STAFF REPORT

SUBJECT: H-2021-0099
I-84 + Meridian Road – CPAM, AZ

Amendment to the Comprehensive Plan Future Land Use Map (FLUM) to change the future land use designation on 33.13-acres of land from Mixed Use – Community (MU-C) to Mixed Use – Regional (MU-R); and annexation of 18.30-acres of land with a C-G (General Retail and Service Commercial) zoning district.

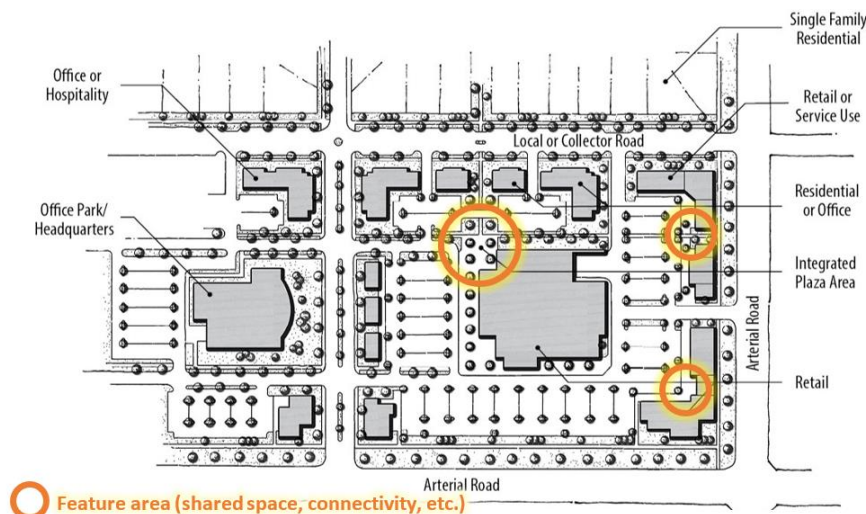
Figure 3D from City of Meridian Comprehensive Plan. Note the special focus on uses with roadway frontage, the unimpeded and direct pedestrian access without traversing frequent parking aisles, the opportunities for a variety of community serving uses (not just high visibility pad sites) and the shared amenity spaces and open space for both the large anchor and smaller pad sites and uses.

C. Conceptual Development Plan

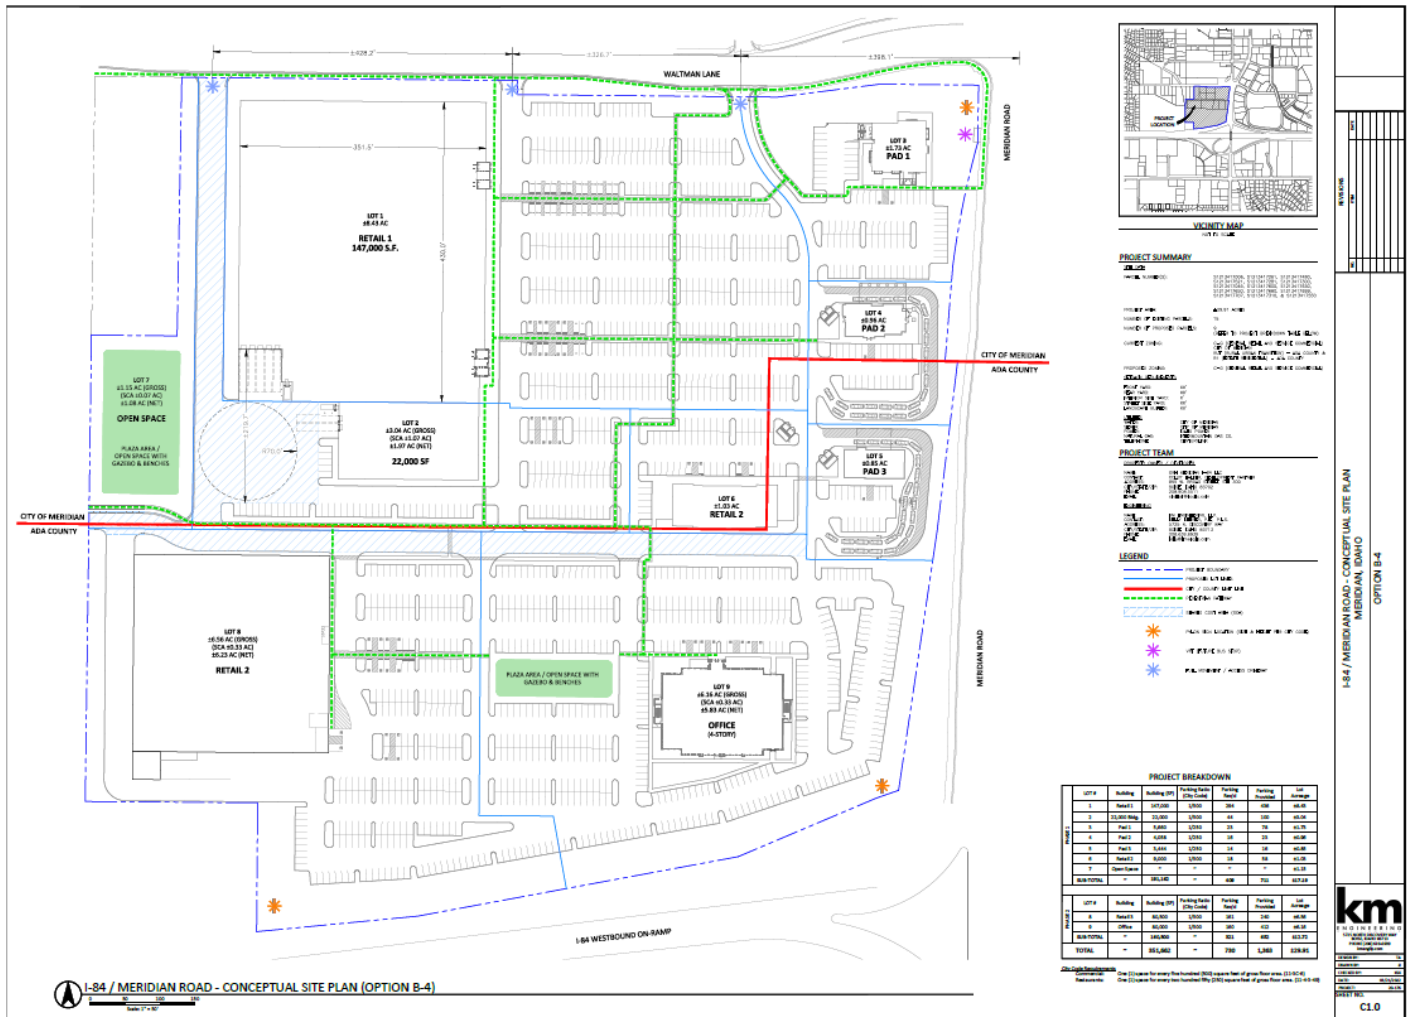
A conceptual development plan was submitted as shown in Section VIII.C that depicts how the property proposed to be annexed, as well as the area currently zoned C-G, is planned to develop with two (2) big box retail stores and a junior anchor retail space [Retail 1 (130,000-150,000 square feet (s.f.)), Retail 2 (80,000+/- s.f.), Retail 3/Lot 2 (20,000-30,000 s.f.)], 3 out-pads, and a 4-story 80,000 square foot office building. The area shown on the concept plan on the bottom (south) portion of the development area (delineated by a red line) is the portion of the site currently in Ada County proposed to be annexed; the area on the top (north) portion of the development area is the portion of the site currently in the City. The portion of the site currently in the City is entitled to develop subject to UDC [Table 11-2B-2](#) Allowed Uses in the Commercial Districts, regardless of whether or not the proposed annexation is approved, as there is not a Development Agreement in effect for that property.

A vehicular connection/stub is depicted on the concept plan to the property to the west for future extension across the Ten Mile creek and interconnectivity. The Applicant has submitted an emergency access easement agreement with the property owner to the west for access to Ruddy Dr. and Waltman Ln.

As noted above in Section V, mixed use designated areas should include at least three (3) types of land uses. The proposed conceptual development plan for the annexation area (and larger area) only includes two (2) land use types – commercial retail and office. Although residential land uses are *planned* to develop on the adjacent property to the west, the property is currently entitled to develop solely with commercial uses; the previous residential development proposed for that property was denied (i.e. Tanner Creek). Reasons for denial included Council's determination that the sole residential use of the property was not consistent with the MU-C designation because a mix of uses wasn't proposed and they didn't want to burden this property with providing only the non-residential component of the mix of uses desired for this area. Hence, Staff's recommendation for this property and the adjacent property to the west to come in for review concurrently in order to ensure the overall development is consistent with the development guidelines in the Comprehensive Plan for the mixed-use designation.

In accord with Staff's analysis above, the proposed development is *not* consistent with the general mixed-use development guidelines, the existing MU-C or the proposed MU-R guidelines. Therefore, Staff is *not* in support of the requested annexation with the conceptual development plan proposed due to its inconsistency with the Comprehensive Plan.

As recommended in the pre-application meetings for this property and the adjacent property to the west, Staff recommends development applications are submitted concurrently for these properties with a master plan for the overall area that demonstrates consistency with the guidelines in the Comprehensive Plan for mixed use developments and specifically the MU-C designation or an alternate designation if proposed. Alternatively, if submitted separately, the development plan for each property should demonstrate consistency with the Plan on its own merits. The TIS should also be updated to take into
